# Sirius Building Modification 1

Removal and replacement of two trees along Gloucester Walk  
State Significant Development Modification Assessment (SSD  
10384 MOD 1)

March 2022

**Figure 2 |** Location of Trees 50 and 51 (Source: Approved Landscape Plan Basement B2-B1)

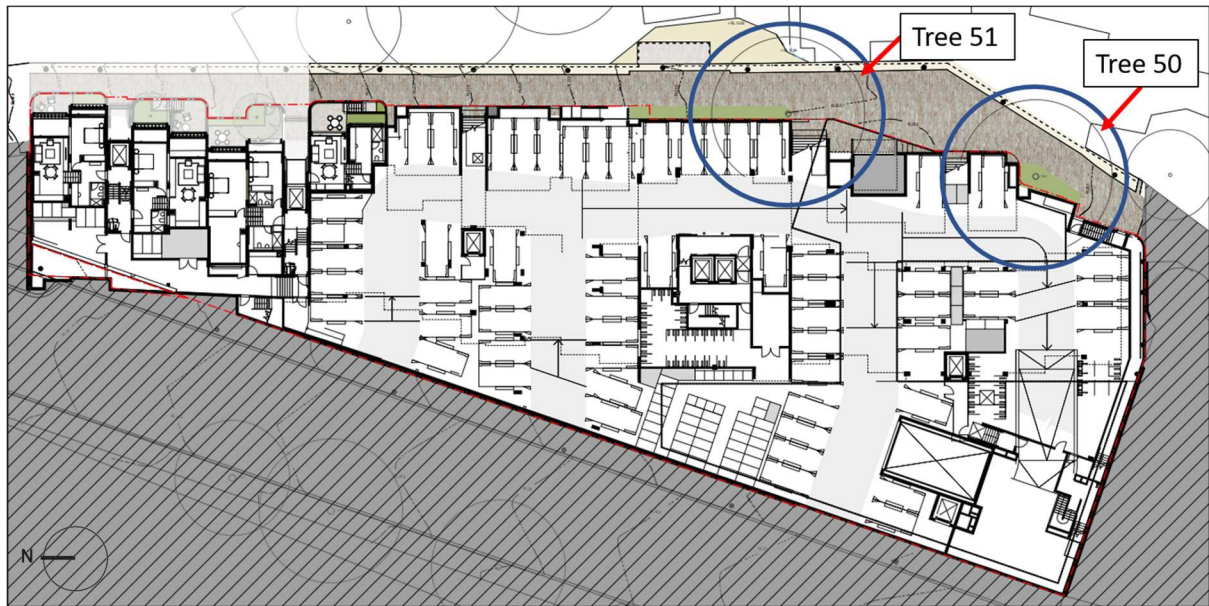
The proposal seeks consent to remove two Plane trees within Gloucester Walk. The trees are located 0.5 m and 0.8 m from the masonry retaining wall beneath the Sirius building.

Council does not support the removal of the trees on the basis of their high landscape value and raised concerns about the root mapping undertaken, the current condition of the wall, and inadequate consideration of alternative options to retain the trees.

- the existing retaining wall is in a state of structural failure and must be replaced to allow the redevelopment of the Sirius building in accordance with the development consent
- the demolition of the existing wall would render the trees unstable due to their structural dependence on the wall and adjacent soil
- the Applicant and the Chief Engineer have sufficiently explored alternative means of constructing the new retaining wall to retain the trees, however these options are not feasible due to engineering and spatial constraints
- further detailed investigations will not alter the engineering assumption of the load on the current wall and significant risk of the trees collapsing, either inwards towards the basement or across Gloucester Walk during demolition/construction.

On this basis, the Department has found that the retention of trees would create an unacceptable safety risk given their proximity to, and the need to replace, the existing structurally failing wall beneath the Sirius building. The Department therefore concludes that the proposed removal of the trees is the only safe and practical option to allow the redevelopment of the Sirius development to proceed.

**Figure 3 |** Four proposed trees along Gloucester Walk (Source: Landscape Plan Basement B2-B1)

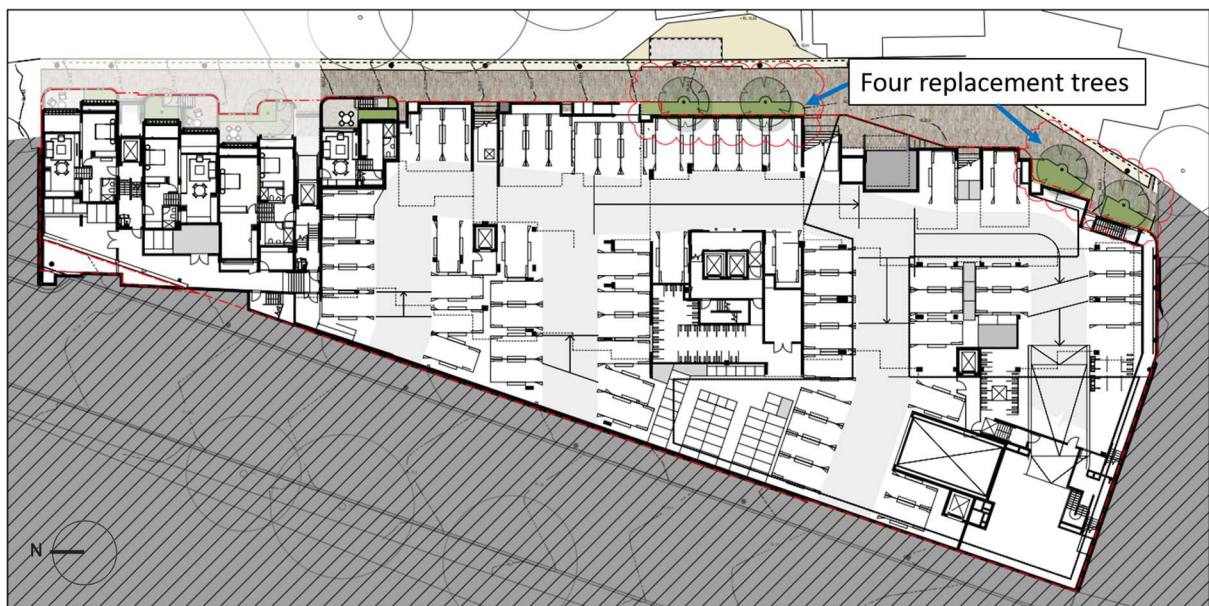
The Applicant proposes to plant four Black Tupelo trees to replace the removed Plane Trees. The Landscape Architect for the project has advised that:

- the Black Tupelos are smaller and have a less aggressive root system than Plane trees and its columnar canopy shape and form are more compatible with the space
- the species has also been proposed as street tree planting in Cumberland Street and the continuation of the same planting will enhance the amenity and identity of the precinct
- the total canopy cover of the replacement trees (200m<sup>2</sup>), while less than the existing Plane trees (402m<sup>2</sup>), when considered in the context of the approved street tree planting along Cumberland Street, represents an increase of 260m<sup>2</sup> more canopy cover than the existing public domain canopy area.

Council recommended that any replacement trees should be in accordance with the specifications of Council's Street Tree Manual 2011 for The Rocks area.

PMNSW did not raise any concerns regarding the proposed tree species but advised that replacement planting should be determined in consultation with Council and PMNSW.

The Department notes that Black Tupelo are not listed as a preferred species in the Council's Street tree manual and therefore recommends a condition requiring the final trees species and sizes be determined in consultation with Council and PMNSW.

**Figure 5** | Sections indicating locations of Trees 50 and 51 and the retaining wall to be demolished (red hatched) (Source: Structural engineer advice dated 21 September 2021)

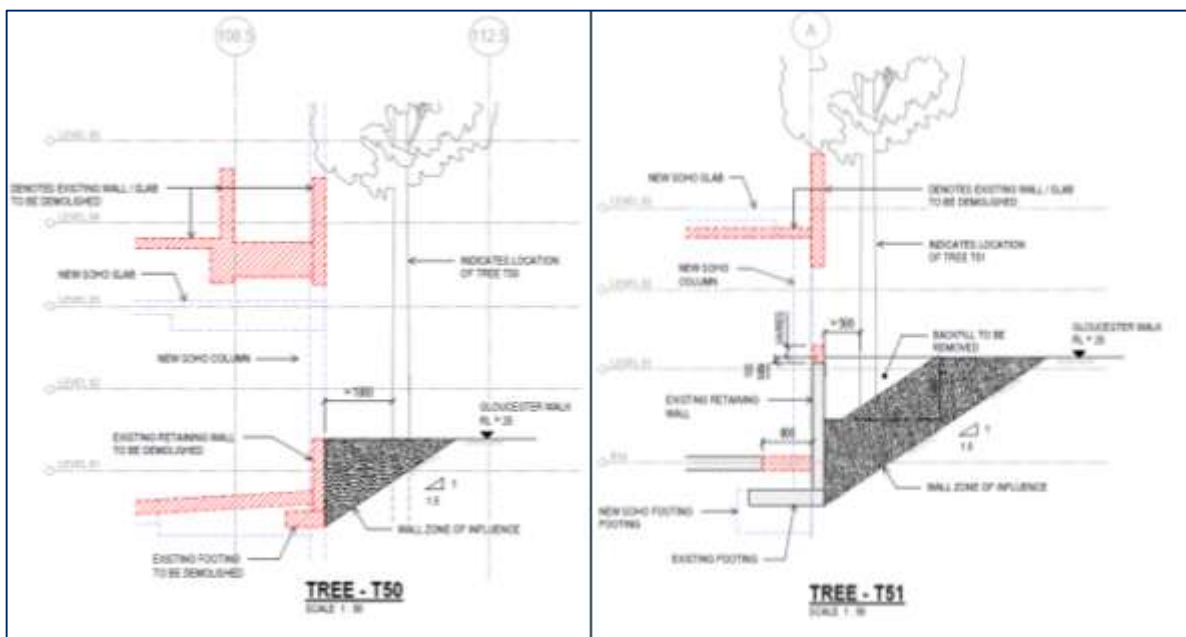
The Applicant, however, has now advised that the removal of the trees is required to facilitate the demolition and reconstruction of the existing retaining wall which has structurally failed, is not certifiable under current Australian Standards and fails National Construction Code strength and stability requirements.

- the root ball of the trees is exerting pressure behind the wall as evidenced by cracking, twisting and visible root penetration
  - demolition of the wall, including removal of soil behind the trees would be likely to result in:

- the collapse of existing soft ground material inwards which gives rise to the risk of significant injury or death to workers.
    - instability of tree roots results in overturning of trees over Gloucester walk and the public below.

- the input parameters and assumptions of the Applicant's engineering advice are accurate and appropriate, and the results of the analysis clearly indicate that the wall is overloaded and in a state of structural failure

- the current wall cannot be certified as compliant with current standards and needs to be replaced
- there are limited options to safely construct the wall and retain the trees, in particular:

- Council's proposed option of using rock anchors to support the existing retaining wall is not feasible due to engineering constraints and public safety risks

- the internal basement height is too low to accommodate machinery to build a soldier pile wall behind the original wall, as recommended by Council
  - a replacement wall, without soldier piles, cannot fit into the space available

- more comprehensive tree root mapping would not better inform whether the trees are able to be retained.

The Chief Engineer therefore concluded that the safest, most practical means to complete the project is for the trees to be removed.
